CASE #PL2020-133

PERSPECTIVE- 86TH STREET LOOKING WEST

PENN CITY HOMES

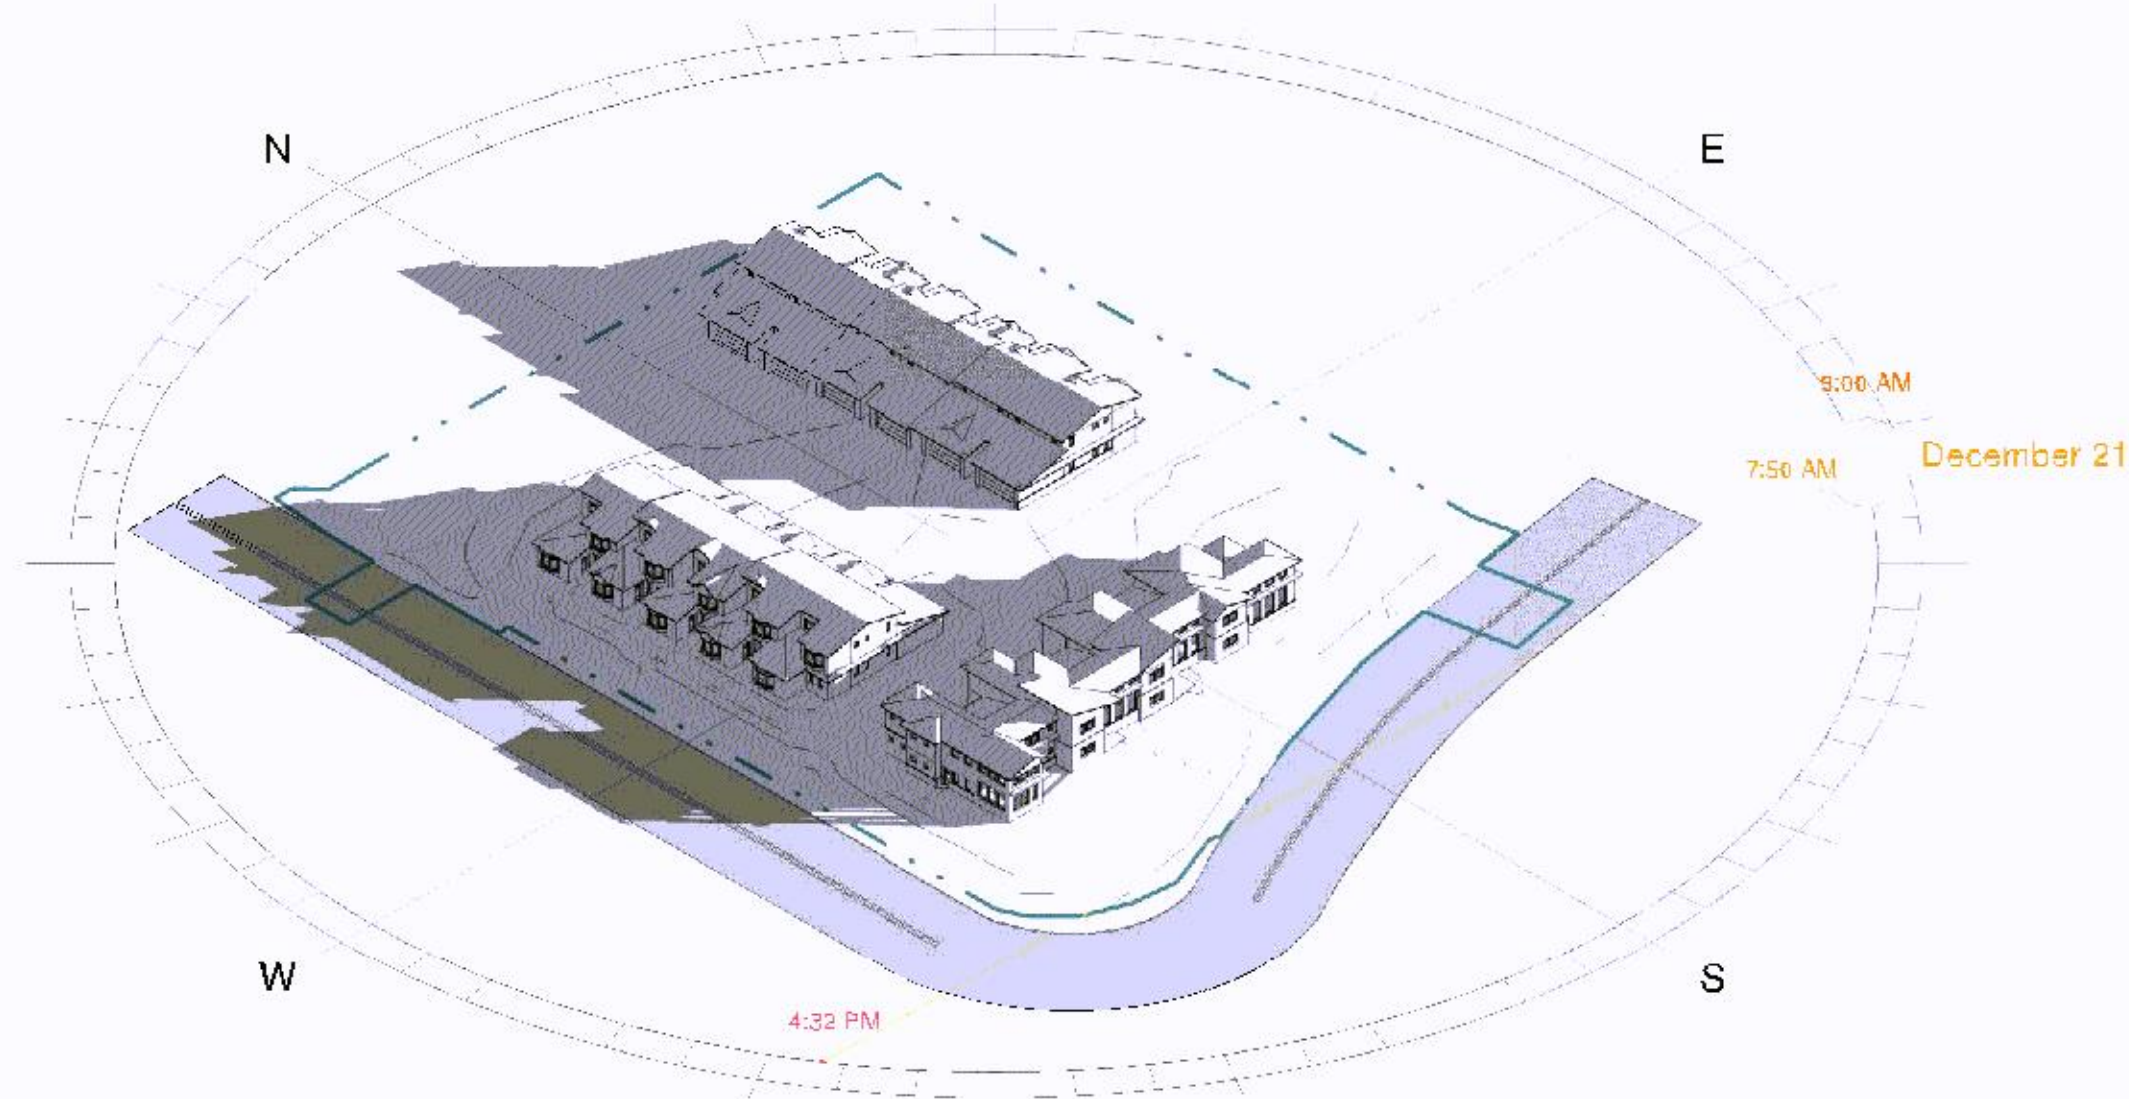
Must meet 2020 MN State Building Code

Provide a code analysis with the plans.

SAC review by MET council will be required.

Provide adequate turning radius to accommodate BFD Ladder 1

All units required to be sprinklered.
